#### APPEAL SUMMARY

<b>Appeal ID:</b> 24858	<b>Project Address:</b> 700 N Buffalo St
<b>Hearing Date:</b> 5/12/21	<b>Appellant Name:</b> Jeff Reynoldson
<b>Case No.:</b> B-001	<b>Appellant Phone:</b> 19712581569
<b>Appeal Type:</b> Building	<b>Plans Examiner/Inspector:</b> Jason Buerkle
<b>Project Type:</b> residential	<b>Stories:</b> 2 <b>Occupancy:</b> Accessory Building <b>Construction Type:</b> Wood construction
<b>Building/Business Name:</b>	<b>Fire Sprinklers:</b> No
<b>Appeal Involves:</b> Reconsideration of appeal	<b>LUR or Permit Application No.:</b> 21-003390-RS
<b>Plan Submitted Option:</b> pdf [File 1] [File 2]	<b>Proposed use:</b> Accessory Use

# PROJECT DESCRIPTION: ADD UNCONDITIONED ACCESSORY SPACE ABOVE EXISTING DETACHED GARAGE

PERMIT # 21-003390-RS

WALL SECTION AT GABLE

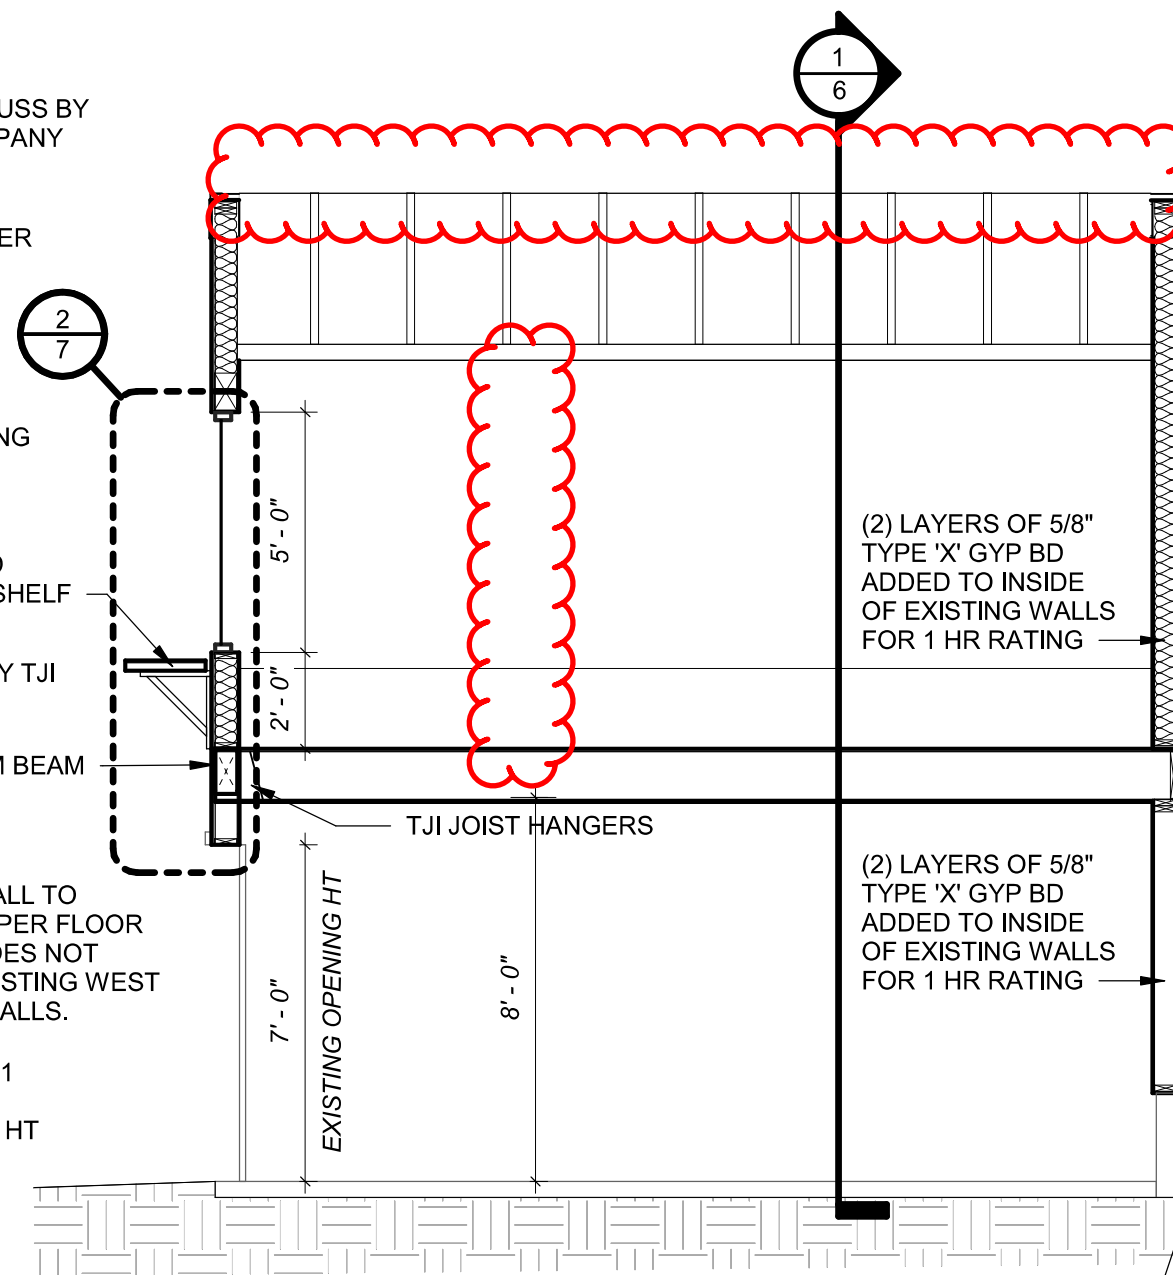
<b>Code Modification or Alternate Requested</b>	We request an alternate to the fire protection for the exterior walls of a detached garage accessory structure along the east and south property line. The alternate would be to provide the required 1-hour protection from the inside only.
<b>Proposed Design</b>	Two existing exterior walls (east and south walls) of a detached garage accessory structure is within 3 feet of the property line. Due to the conditions of the existing construction, in lieu of

proposing one layer of Type 'X' fire-rated gypsum board be installed on each side of the wall, an alternate means for providing two layers of Type 'X' gypsum board on the inside surface over the face of wood studs is proposed. The proposed alternate is intended to meet the intent of the code and safety concerns for 1-hr fire resistance. The two layers of 5/8" Type 'X' gypsum board offers equivalence of 1-hr fire resistance from inside the structure where the source of fire could occur. The gypsum wallboard will extend from existing concrete foundation to the underside of the roof sheathing. Solid 2x blocking will be provided when the floor joists are perpendicular to the property line to allow the fastening of the (2) layers of Type 'X' gypsum board. The only interruption will be the floor sheathing of the storage space as required by the structural engineer. See drawings. The 1-hour fire rated exterior walls would be per the following assembly (outside->in):

We are now finishing the interior of the structure and are safely able to apply (2) layers of wallboard to the interior and would have more quality control if both layers are installed within the interior. The gypsum wallboard will be extended to the bottom of roof sheathing. See details. Blocking will be used at the eaves.

**Alternate one hour assembly for South and East walls of existing garage within three feet of property line: Granted provided:**

- a. Two layers of Type X gypsum are installed on the interior side of the wall continuous to the top of the double top plate.**
- b. Two layers of 2x blocking are provided between the top of the double top plate and underside of the roof sheathing, beveled where required, to fit tight against the sheathing.**
- c. No openings including eave vents may be installed in the soffit and no openings including windows, roof vents or skylights may be installed in that portion of the wall or roof that is within three feet of the property line.**
- d. The roof sheathing adjacent to the property line is fire resistant treated for a minimum distance of 4 feet from the roof edge.**
- e. No built elements including gutters and footings may cross the property line and stormwater must remain and be disposed of on site.**
